## BYLAW NUMBER 41P2021

**BEING A BYLAW OF THE CITY OF CALGARY  
TO AMEND THE BRIDGELAND-RIVERSIDE  
AREA REDEVELOPMENT PLAN BYLAW 11P80  
(LOC2020-0079/CPC2021-0857)**

Figure 3

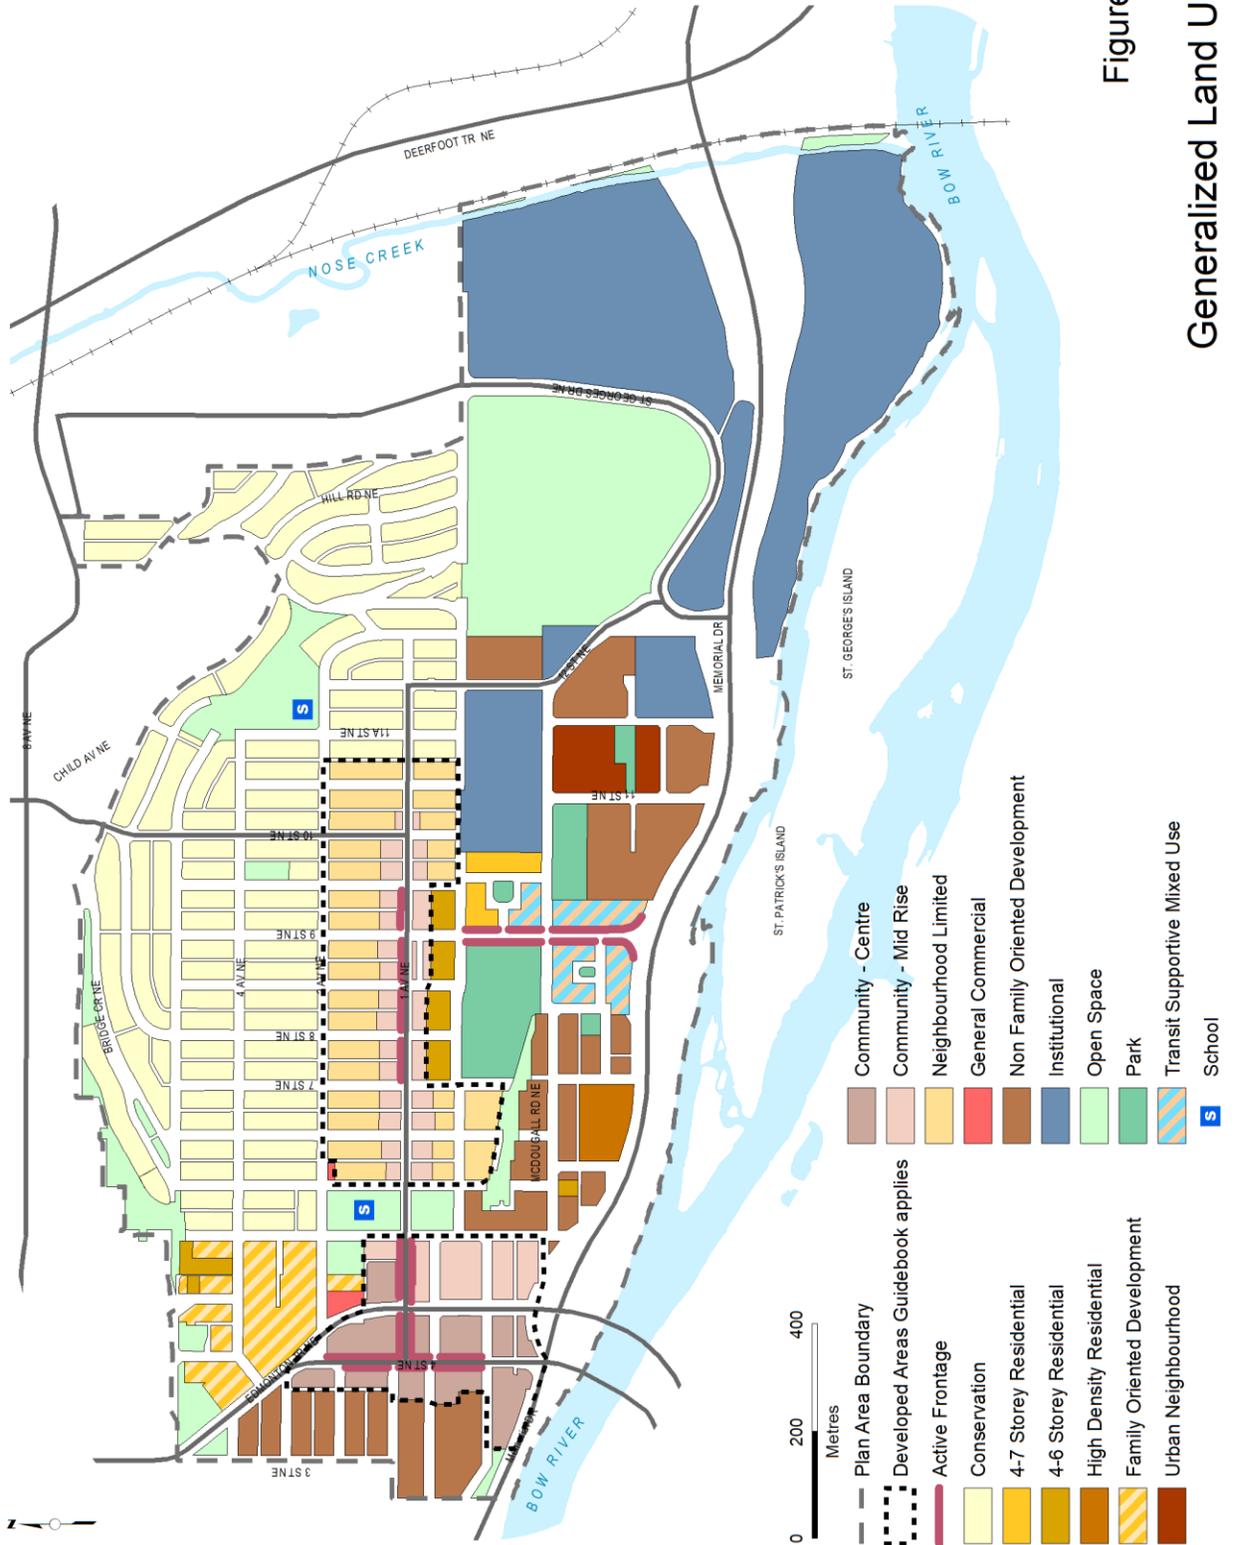
1. The Bridgeland-Riverside Area Redevelopment Plan attached to and forming part of Bylaw 11P80, as amended, is hereby further amended as follows:
  - (a) Delete the existing Figure 3 entitled 'Generalized Land Use' and replace with the revised Figure 3 entitled 'Generalized Land Use' attached as Schedule A.
  - (b) In Part 2, Section 3 Residential, Implementation, after policy 19 add the following:
